Programmatic **Environmental Impact Statement**

related to decontamination and disposal
of radioactive wastes resulting from
March 28, 1979 accident
Three Mile Island Nuclear Station, Unit 2
Docket No. 50-320

Final Supplement Dealing with
Occupational Radiation Dose

**U.S. Nuclear Regulatory
Commission**

FIGURE 1.3. Number of Workers Versus Yearly Occupational Dose for TMI-2

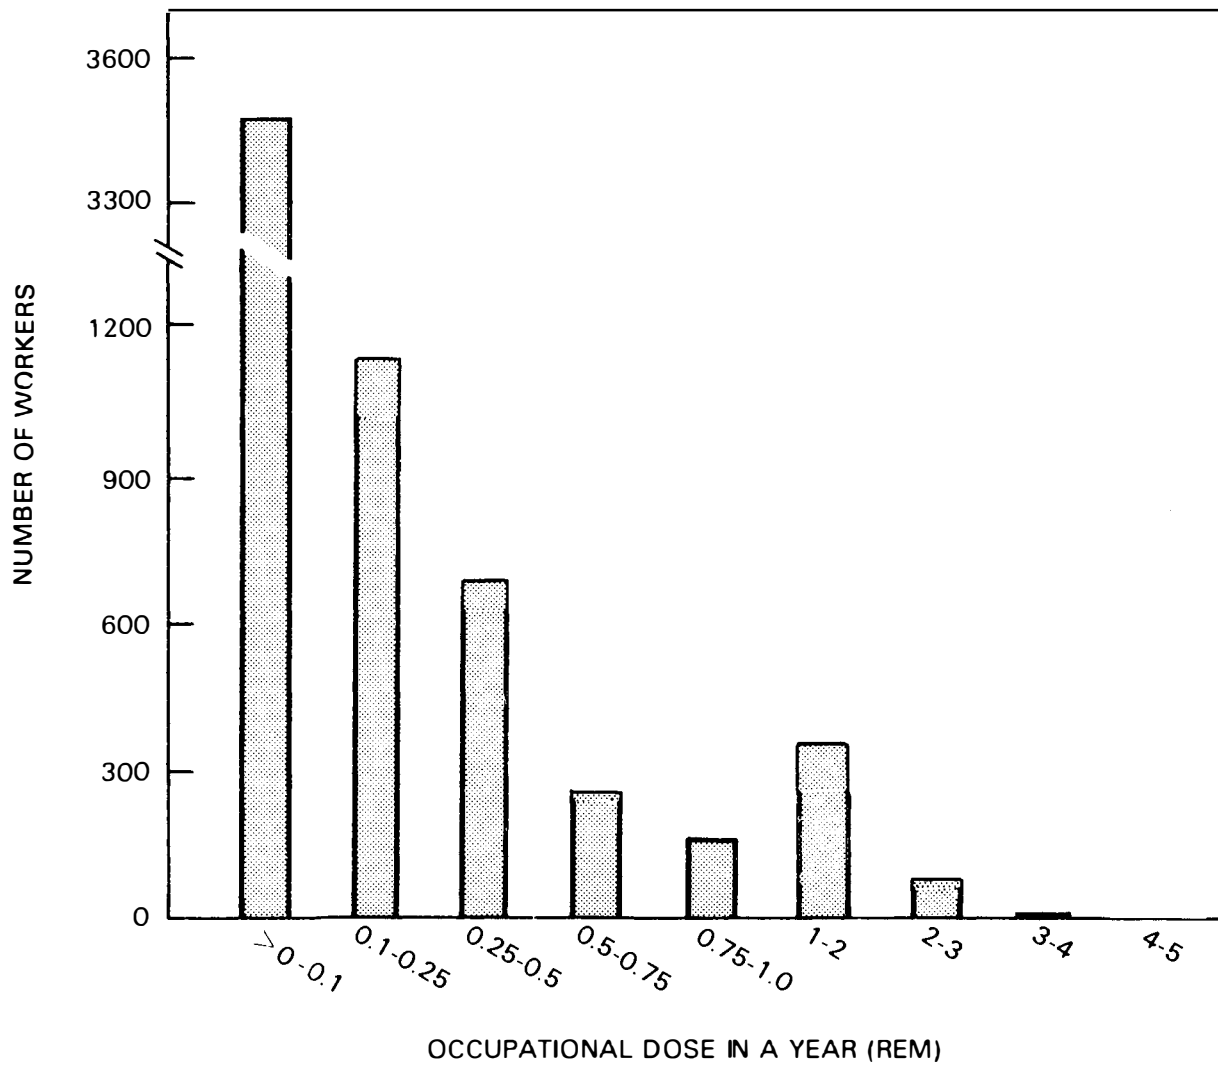
Page	Paragraph	Line	Comment				
				1.8	2	13	Change "the work" to read "each task".
				1.8	3	1	Change "done" to "performed".
				1.9	Figure 1.3		Delete figure and replace with new figure from data in Attachment 4.
Cover Sheet and Abstract	4	9	Change "1700 person-rem to read "1814.1 person-rem based on self-reader data. . . required."	2.1	Section 2.1.1	5	Change "430 mrem/hr" to "0.430 person-rem/person-hour".
iii	2	3	Change "August 1983 to "December 1983" and "1700 person-rem" to "1814.1 person-rem". These changes should be made throughout this Supplement to the PEIS	2.3	1	1	Change "140 mrem/hr" to "0.145 person-rem/person-hour".

FIGURE 2.6. Cutaway View of TMI-2 Vessel

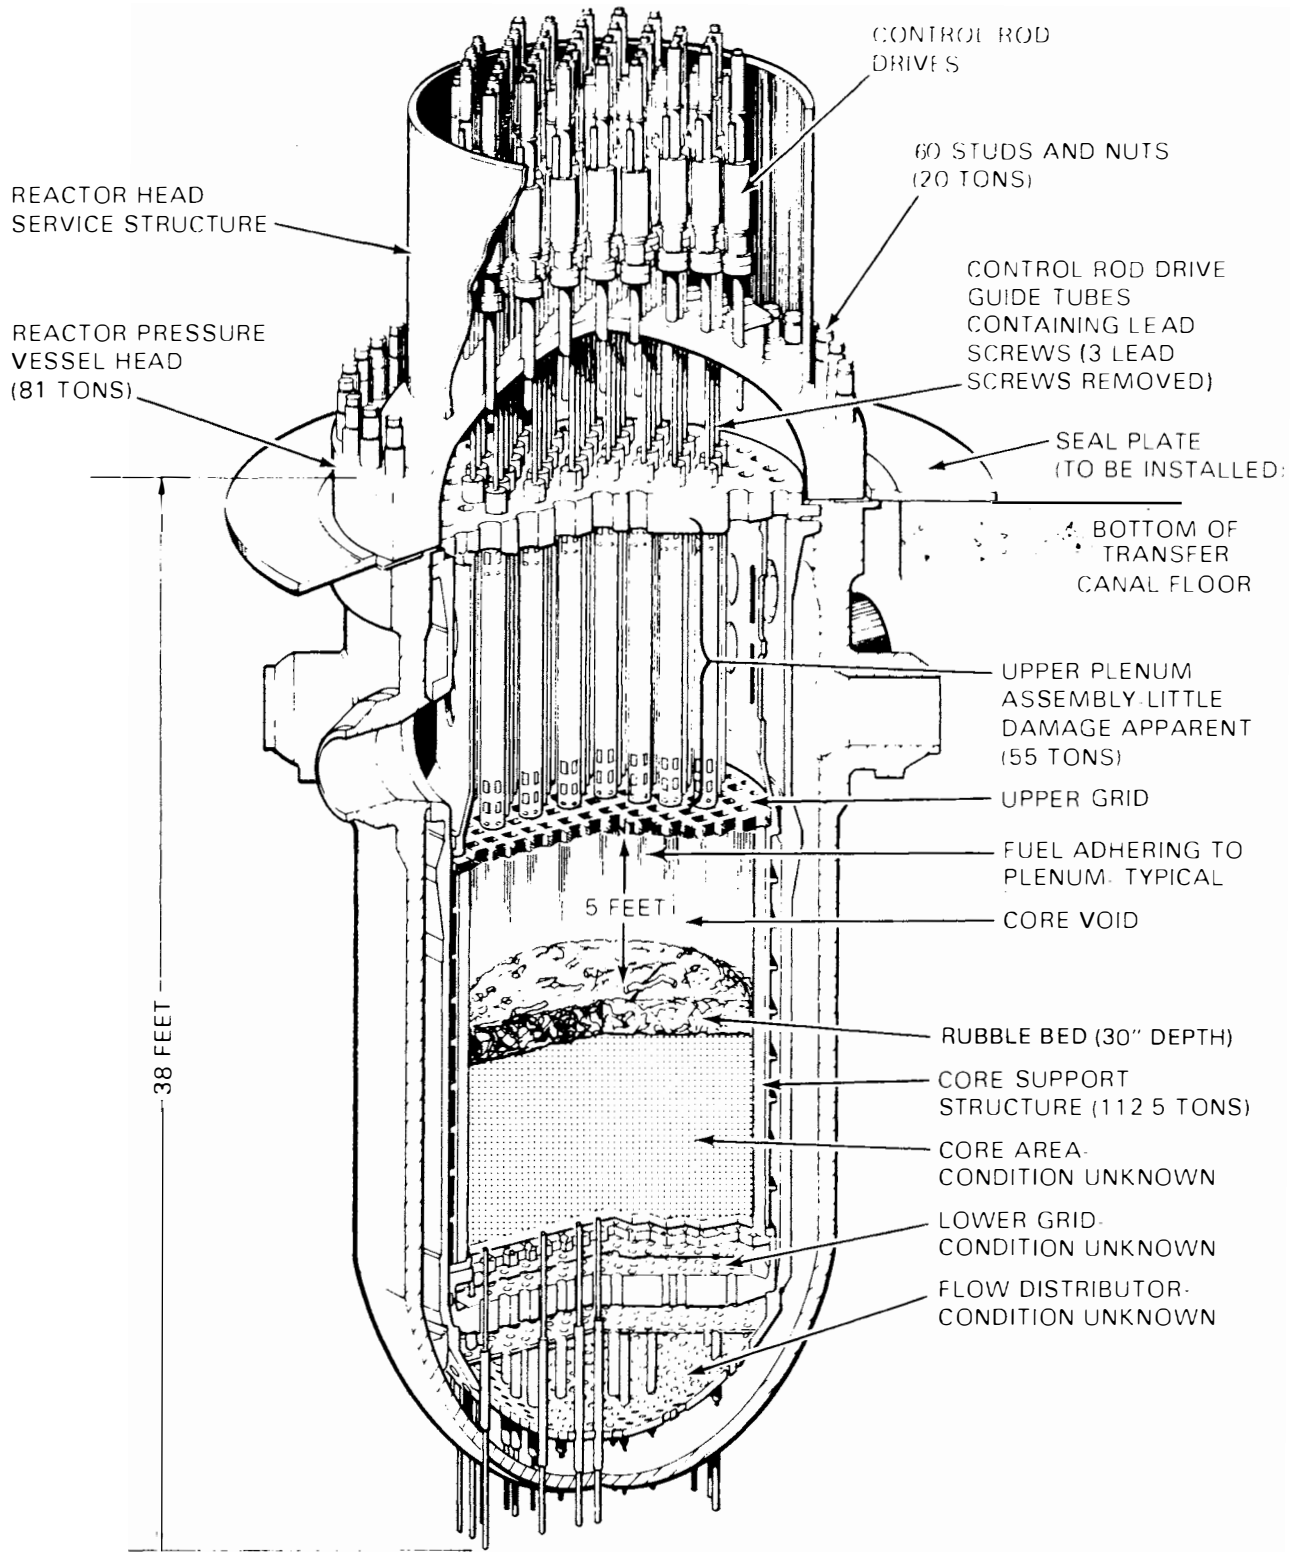
- 1) Below the upper plenum there is a core void of about 5 feet where fuel assemblies have been completely destroyed. Under this there is a rubble bed at least 14 inches in depth. "The conditions below the rubble are not known." (p. 2.8)
- 2) Figure 2.6, a cutaway view of the TMI-2 reactor vessel, shows this uncertainty as to the condition of

FIGURE 2.10. Conceptual Schedule for the Current Plan
 (a) an interval represents a time period of 6 months to 2 years - see Section 2.6.3.

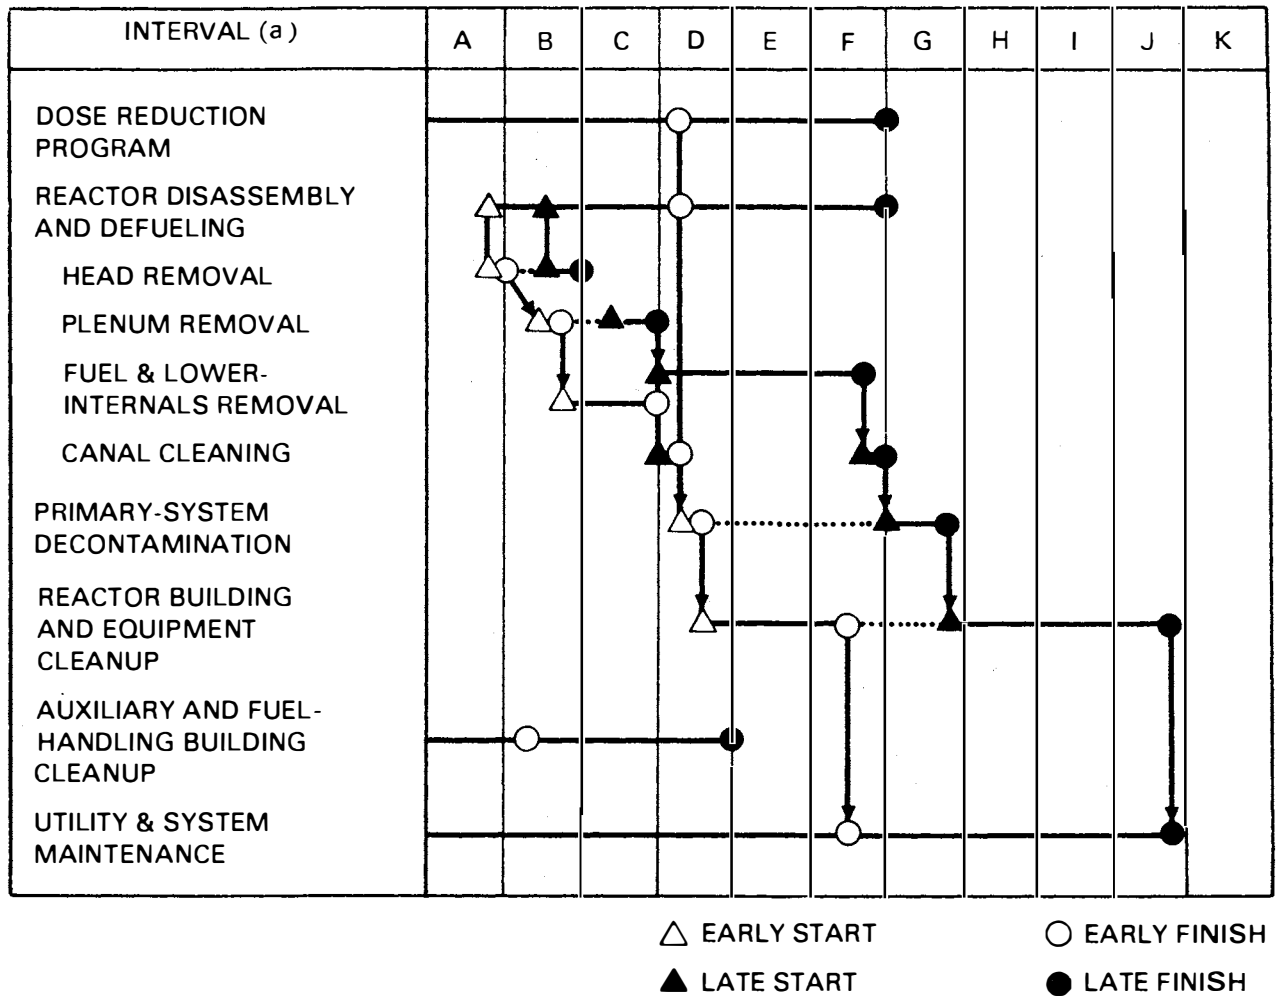
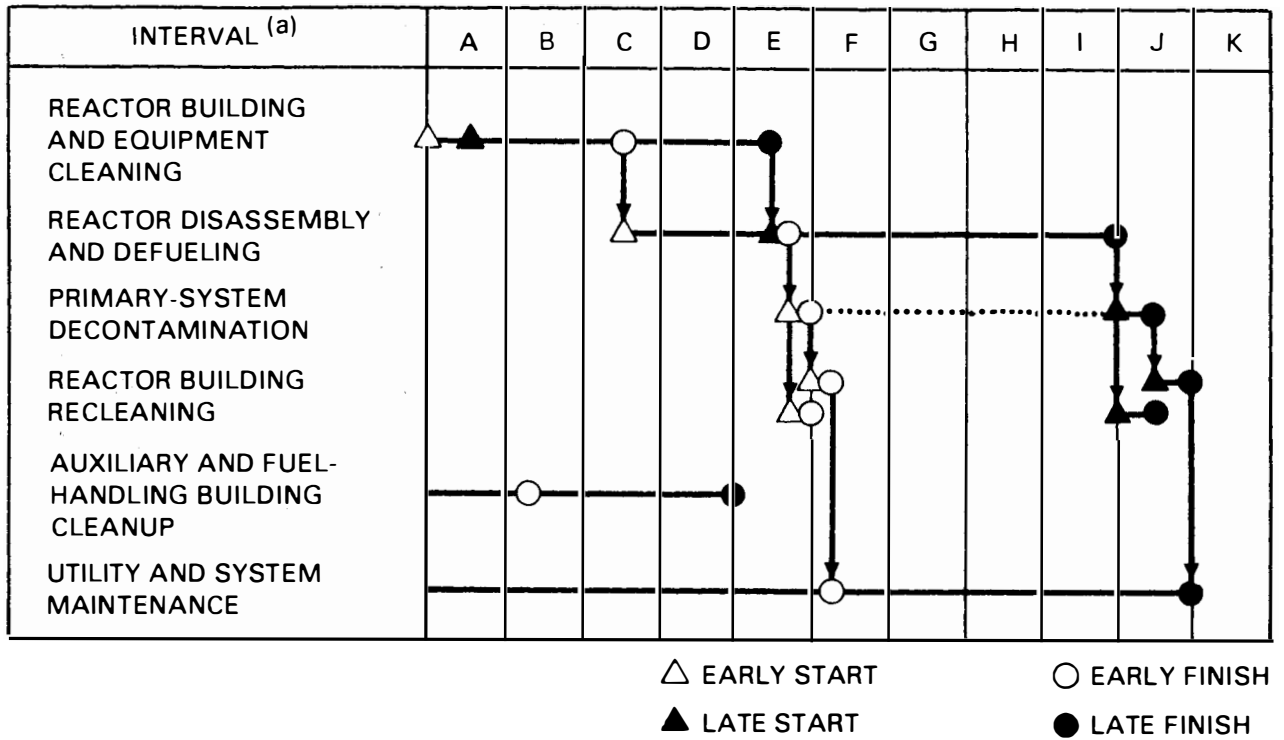
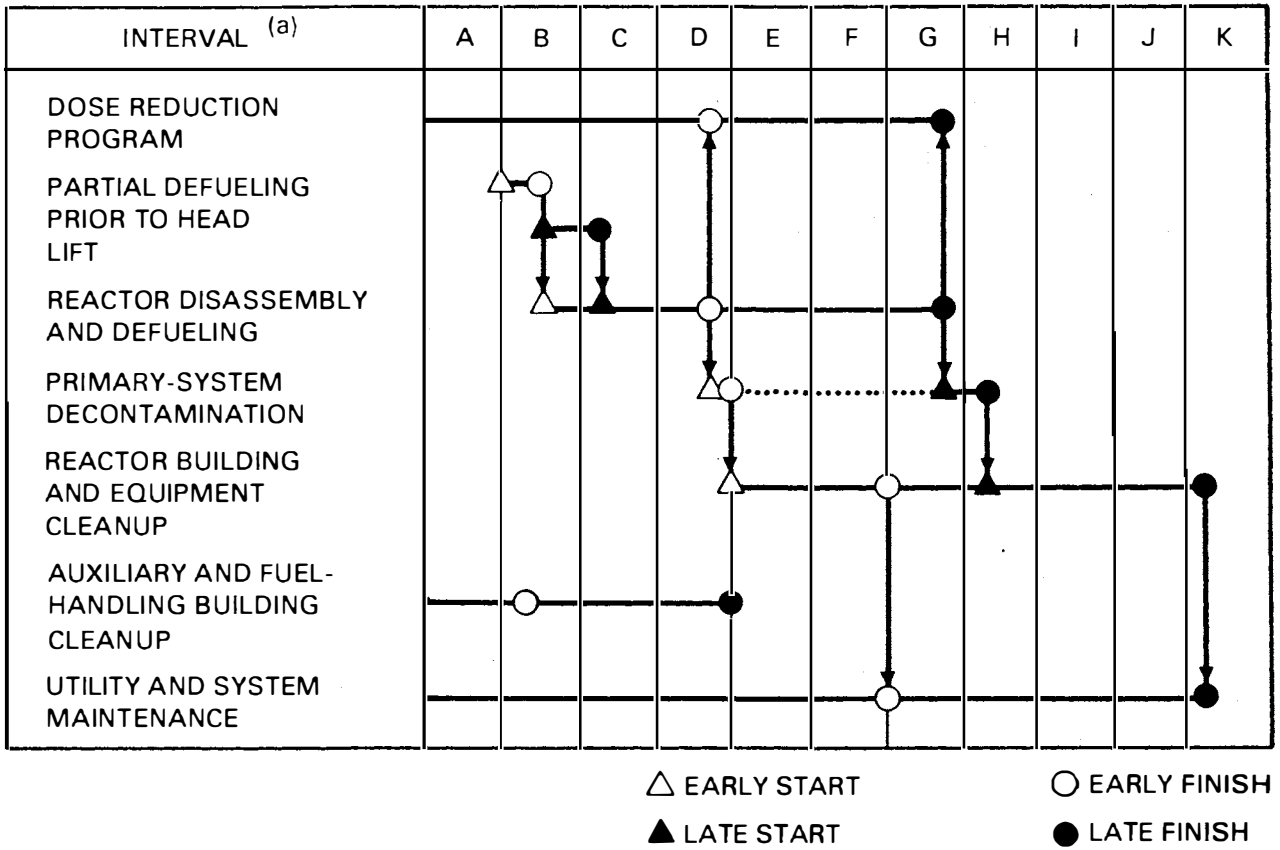
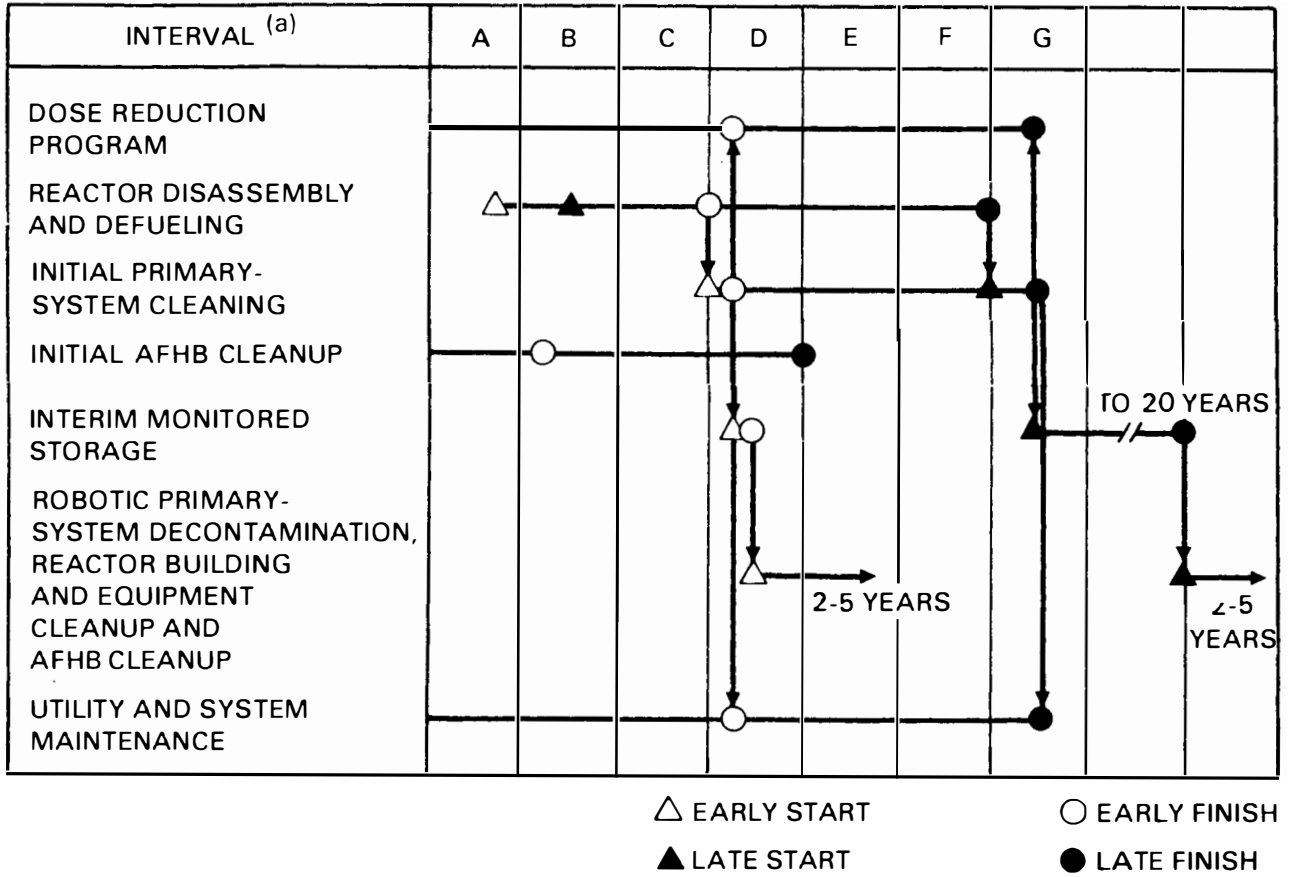
A statement should be added to Table 2.1, "Licensee's Goals for Dose Rate Reduction", to indicate that these goals are only target values used as a basis for an estimate. They may not be attained and are not a constraint for moving into another period on the cleanup. Additionally, the periods listed in this table are not consistent with the periods shown on Figures 2.10 through 2.13 and as discussed in Section 2.6.3.
